INNER WEST COUNCIL

DEVELOPMENT ASSESSMENT REPORT

Application No.	DA201800430
Address	220 Marrickville Road, Marrickville
Proposal	To carry out alterations and modify the ground floor layout of the approved Hotel and to carry out works to the first floor and fit-out for use as tourist and visitor accommodation.
Date of Lodgement	17 October 2018
Applicant	Alex Papas
Owner	Mr Michael Papacostas & Araquara Pty Ltd & Mr Haricilia Papacostas
Number of Submissions	18
Value of works	\$97,000
Reason for determination at Planning Panel	More than 10 objections
Main Issues	Accessibility, internal amenity and residential amenity impacts
Recommendation	Refusal
Attachment A	Plans of proposed development
Attachment B	Plans of the approved development (DA201500516.01)
Attachment C	Conditions in the circumstance the Development is Approved

DEVELOPMENT APPLICATION
PROPOSED HOTEL
220 Marrickville Rd.
Marrickville, NSW
DA/01
GENERAL ARRANGEMENT
SCALE 1:100 @ A1

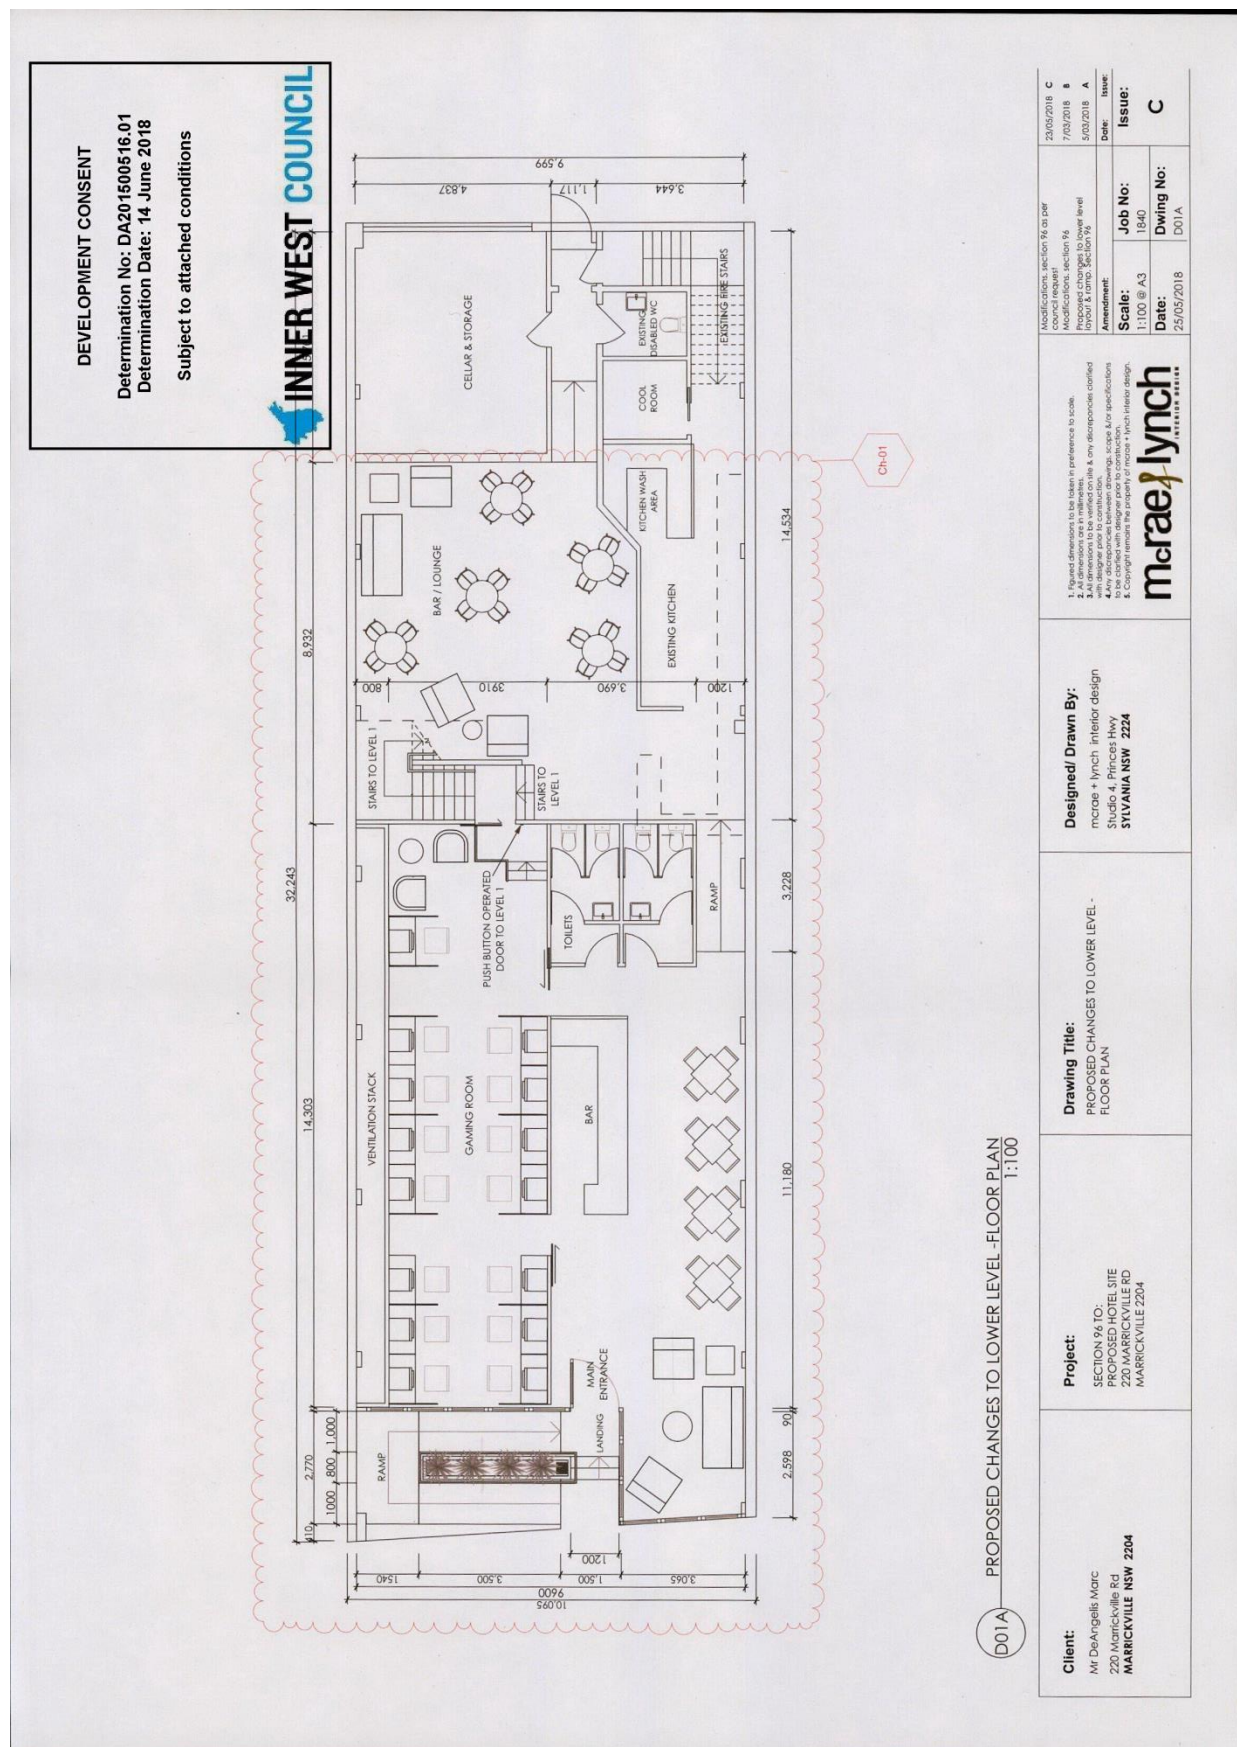
The application was referred to Council's Building Surveyor who raised concerns with the required path of travel, which would be through the bar and dining area to the lift access at the rear of the premises. The internal access arrangement is considered to be unsatisfactory and not in compliance with dignified access to a building for persons with a disability. Concerns were also raised with the proposed stairwell at the front of the building, resulting in patrons exiting the first floor midway within an accessible ramp. Council's Building Surveyor considers that the resolution of these issues would require a significant redesign to ensure there is direct access to the street and no conflict between the alternative means of access to the premises.

In addition to the above, a significant concern remains regarding accessible entry outside of the ground floor premises operating hours. As the nature of Hotel accommodation requires 24 hour access, and the lift is located at the rear of the ground floor, it is unclear how Hotel guests could access this when the pub is not operational.

MDCP 2011 requires one accessible bedroom per five guests' rooms. Based on a total of fifteen rooms, the proposal requires a total of 3 accessible rooms. The plans submitted with the DA show 1 accessible Hotel room. The Statement of Environmental of Effects (SEE) submitted with the application states the development can satisfy the requirements of the BCA in relation to the accessibility requirements in Part 2.5 of MDCP 2011. However, there is no evidence to substantiate the assertion made in the SEE. Furthermore, the application fails to provide an Access Management Plan addressing the Disability (Access to Premises-Buildings) Standards 2010 and/or the Building Code of Australia (BCA).

In addition to the above, the application fails to adequately address any potential impact of overlooking from the first floor Hotel to the dwellings located to the rear of the site. The approved first floor plan previously located an office, storage room and maintained an existing WC and shower cubicle at the rear of the site, each containing a window serving the spaces. The proposed development seeks to maintain the WC and shower cubicle but also locates 2 Hotel rooms facing the rear of the site with no provision for any privacy measures to mitigate impacts of overlooking into the rear yards of neighbouring properties located across the lane, namely 19 and 21 Fernbank Street.

In addition to the above, the proposal fails to adequately demonstrate adequate levels of amenity for the proposed first floor use. Only 4 of the 15 Hotel rooms contain a window to provide outlook and ventilation while 9 rooms provide only a skylight to provide light and air. There is no indication if the provision of existing plant is sufficient for the mechanical ventilation required to support these rooms.

The internal layout includes a storeroom of 5 m² but fails to make provision for other facilities commensurate with the operation of a Hotel, including a reception area, linen and baggage store, garbage room, cleaner's room, lounge area or office.

The Plans submitted with the DA also fail to show the furniture layout of the Hotel rooms to demonstrate the intended capacity (single or double rooms) and amenities such as secure lockable storage, bar fridge, cupboards and shelves.

1. Detailed floor plans showing the internal layout of each of the hotel rooms must be submitted to and approved by Council.
2. Provision of an Access Management Plan, prepared by an Accredited Access Consultant addressing the following;

6. Amended plans illustrating the provision of a minimum of 3 accessible rooms in accordance with the requirements of Part 2.5 of Marrickville Development Control Plan 2011.
